Office Action Summary

10/054,575

SHERRER, DAVID W.

FIG. 1

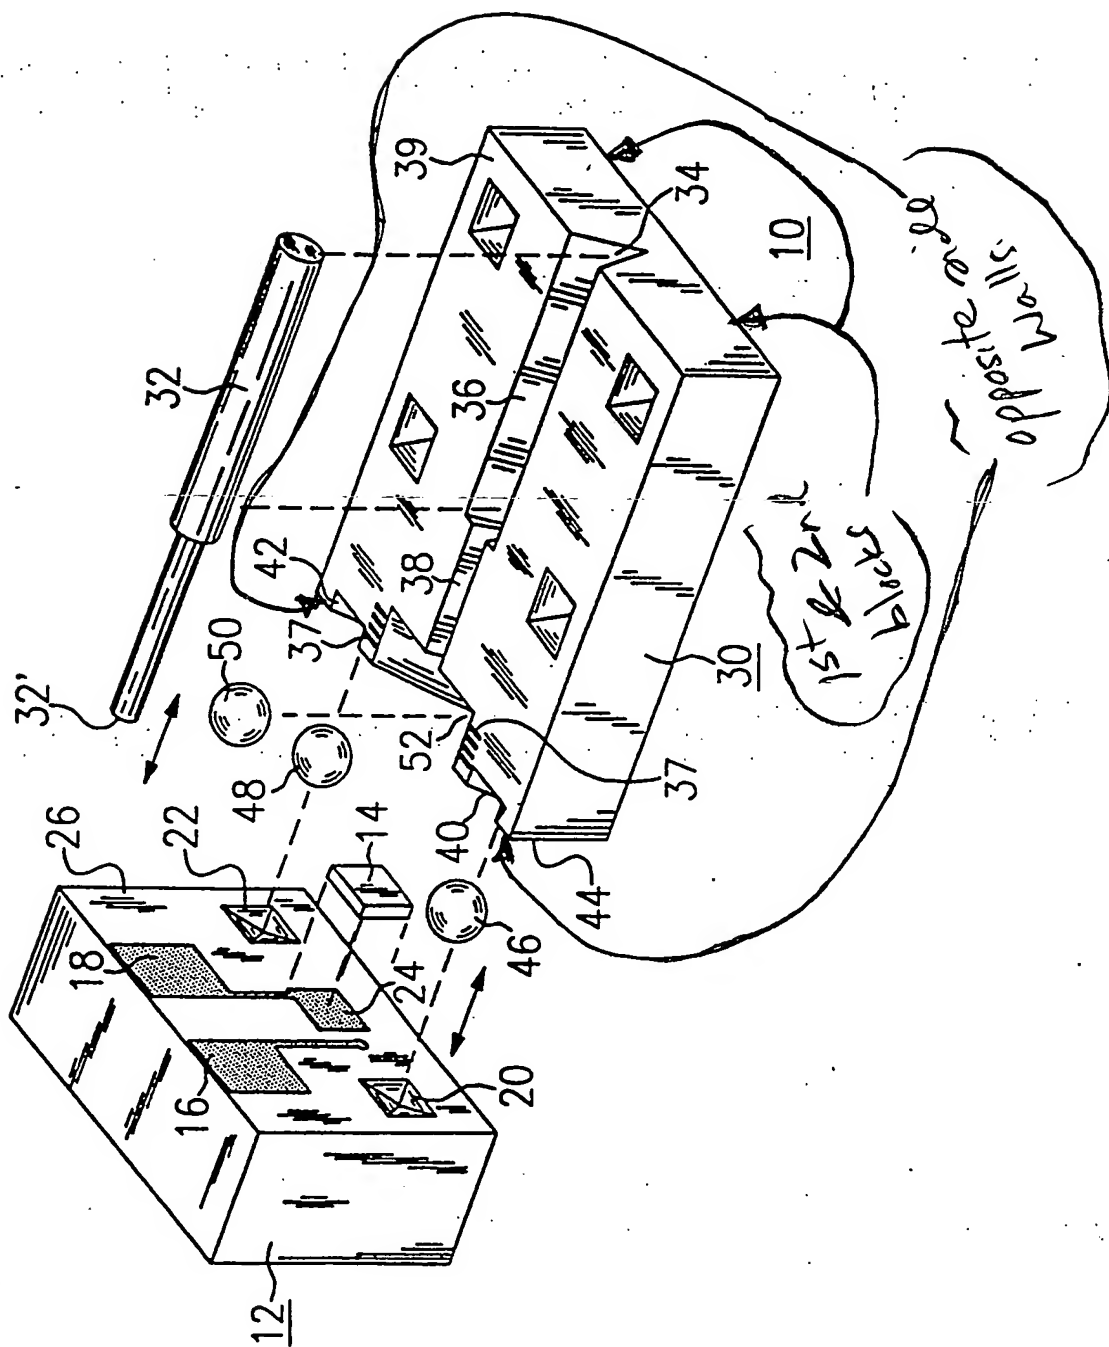
Blonder et al discloses (see figure 6), a first connector (30) having at least one optical component disposed therein, the first connector having opposite side walls (see marked figure 1, attached). Each side wall including a groove (40, 42) defined therealong, a pair of alignment spheres (46, 48) each having a sphere center and a second connector (12) having a planar front face and at least one optical component disposed therein, the second connector including a pair of recesses (20, 22) defined in the planar front face, the recesses being dimensioned to at least partially seat

Blonder et al discloses all the limitations of claims 1 and 11, as shown above. Blonder et al also discloses first and second blocks (see marked figure 1, attached), each block having a major surface (note: **major** is not defined) in a crystallographic plane, the major surface of the first block being joined to the major surface of the second block, the major surfaces of each block being etched to form at least one longitudinal groove (34) for receiving an optical signal carrier,

Blonder et al discloses a first connector (30), opposite side wall (see marked figure 1, attached), longitudinal V-shaped groove (40, 42), alignment spheres (46, 48), a second connector (12), a pair of recesses (20, 22), the recesses being dimensioned to at least partially seat the alignment spheres such that each of the sphere center is distanced from the planar front face so as to mechanically engage a corresponding groove defined within the side walls of the first connector, first and second blocks (see marked figure 1, attached), each block having a major surface (note: **major** is not defined) in a crystallographic plane, the major surface of the first block being joined to the major surface of the second block, the major surfaces of each block being etched to form at least one longitudinal groove (34) for receiving an optical signal carrier,
